MEMORANDUM

REVIEW TYPE: Preliminary Plan Review

PROJECT NAME: Fanning Property

CASE #: 120061030

**PRELIMINARY PLAN
 FANNING PROPERTY
 6108 River Road, Bethesda, MD
 BETHESDA, MARYLAND (ELECTION DISTRICT 04)**

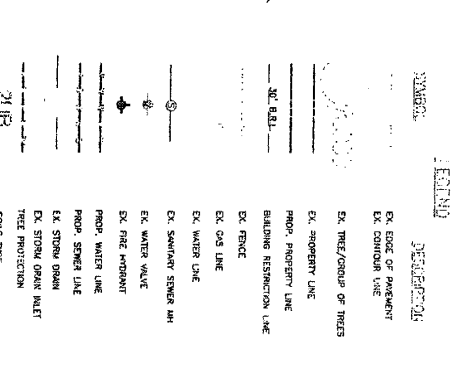
1. Need R/W dedication for River Road (P&P-TP).
2. Access and improvement for River Road per MSHA.
3. Driveway apron not to cross the property line.
4. Need sidewalk.
5. Need SD adequacy.
6. Need sight distance analysis.

1. Tree Save Plan must show and include protection for off-site trees >6" within 25' of the property line. After the identification of trees and their CRZ's per #1, a re-evaluation of the proposed LOD must be conducted in the priority order below to:

a) reflect appropriate protection of the identified trees' CRZ.

The proposed 5' limit of disturbance (LOD) is not considered adequate using standard development practices, but may be needed to provide appropriate tree protection.

2. The approved Stormwater Management Concept is not currently reflected on the Tree Save Plan.

1. Show all existing planimetric and topographic details specifically entire paving, driveways adjacent and opposite the site as well as existing rights of way and easements on the preliminary plan.

7. Adjust the driveways to keep the entire driveways aprons within the property.
8. In accordance with Section 49-35(e) of the Montgomery County Code, sidewalks are required to serve the proposed subdivision. Sidewalks are to be provided along the site frontage.

- The applicant must submit a sight distance evaluation on SHA worksheets.
- The proposed MD 190 entrance geometry is insufficient. The entrance must be 20' wide with 20' turning radii, at a minimum.
- The proposed access is subject to the terms and conditions of a residential access permit, which must be received from SHA's District #3 Utilities Office. The applicant should contact our District Utilities Office at 301-513-7350 for instructions on the application process.
- Right-of-way dedications need to be in accordance with the Master Plan of Highways. SHA will require that right-of-way dedications be platted to SHA standards. These plats must be submitted in hard copy format for review and final plat issuance. Please contact Mr. Daniel Andrews at 410-545-8860 for additional information. You may also e-mail Mr. Andrews at dandrews@sha.state.md.us.
